# CITY OF ALBUQUERQUE

**Re: Opus Transport Apartments  
Traffic Impact Study (M15D023H)**  
Engineer's Stamp DRAFT  
Via email jroberts@tierrawestllc.com

Re: [2023065] – OPUS Transport Apartments – Flightway Ave. at University Blvd. in Albuquerque, NM.

**Figure 3B-23. Examples of Parking Space Markings**

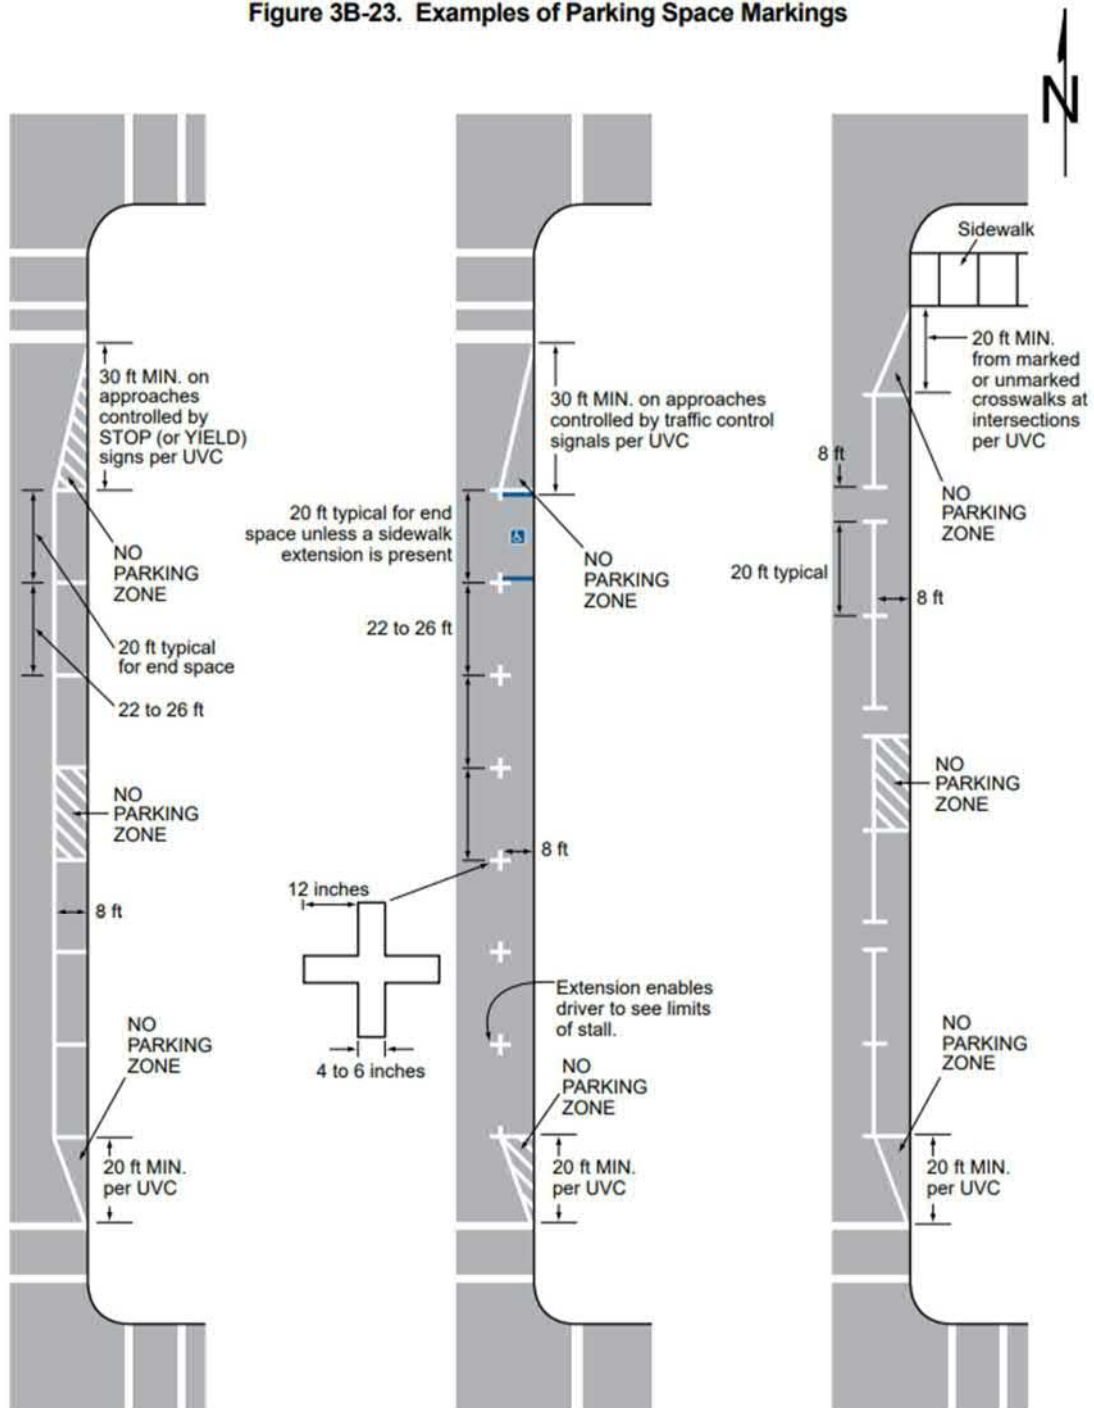
- c) Please extrapolate/provide details on the recommendation “Striping is recommended along the entire roadway to delineate lanes...”.

*Response: Tierra West LLC. has expounded on the recommendations to stripe the existing roadway with the following details beyond what is existing. Existing roadway markings include lane striping at the intersection of Flightway Ave. and University, delineating an exclusive left-turn lane and right-turn lane. The yellow center line markings extend 350 ft west from the stop bar to end of “No Pass Markings” delineating the eastbound and westbound movements. On street parking is available on the north and south sides of both Flightway Ave. and Woodward Rd.*

*The recommendation is to continue on-street parking along Transport St. on the east and west sides, as well as recommended improvements to the existing on-street pavement marking. Improvements include the striping of the parking space to meet MUTCD Section 3B.27 Parking Space Markings standard applies the following:*

*On-street parking space markings shall be white.*
